# Access Compliance Report

## Public Rights-of-Way

### (Curb Ramps)

Intersection ID: 32046	Main Street: REA_RD	Cross Street: COLONY_RD	Location: NW
ADA ID: F62A662FFC51	Ramp Type: Perp	Initial Pass/Fail: Fail	Overall Compliance: No
Severity Score: 13.75			
Codes/Mitigation Info/Possible Solution		Field Measurements/Component Compliance

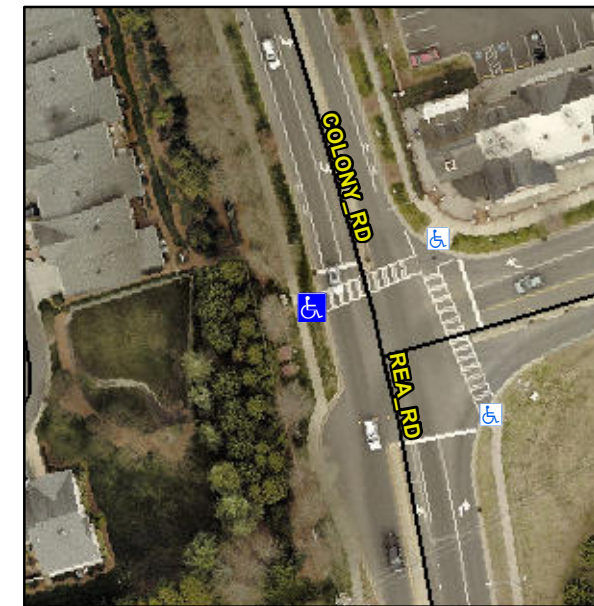
**Not Found, R304.2.2**

Compliance	Description	Data	Compliance	Description	Data
N/A	Ramp Length (in)	101.0	No	Ramp Slope (%)	9.7
Yes	Ramp Width (in)	48.0	Yes	Ramp XSlope (%)	2.3
N/A	Flare Type LT	N/A	N/A	Flare Type RT	N/A
N/A	Flare Slope LT (%)	N/A	N/A	Flare Slope RT (%)	N/A
N/A	Flare Traversable LT?	N/A	N/A	Flare Traversable RT?	N/A
N/A	Landing Length (in)	N/A	N/A	DWS Provided?	N/A
N/A	Landing Width (in)	N/A	N/A	DWS Contrast?	N/A
N/A	Landing Slope (%)	N/A	N/A	DWS Length (in)	N/A
N/A	Landing X Slope (%)	N/A	N/A	DWS Full Width?	N/A
N/A	Landing Curb? (Y/N)	N/A	N/A	DWS Offset (in)	N/A
N/A	Shared Landing?	N/A			
N/A	Gutter Ponding?	N/A	N/A	Gutter Slope (%)	N/A
N/A	Gutter Lip Ht (in)	N/A	N/A	Gutter X Slope (%)	N/A
N/A	Painted X Walk1?	Yes	N/A	Painted X Walk2?	N/A
	X Walk 1 Direction	To NE		X Walk 2 Direction	N/A
N/A	X Walk 1 Width (in)	99.0	N/A	X Walk 2 Width (in)	N/A
	X Walk 1 Slope (%)	3.5		X Walk 2 Slope (%)	N/A
	X Walk 1 X Slope (%)	3.0		X Walk 2 X Slope (%)	N/A

**Remove & Replace Entire Ramp.**
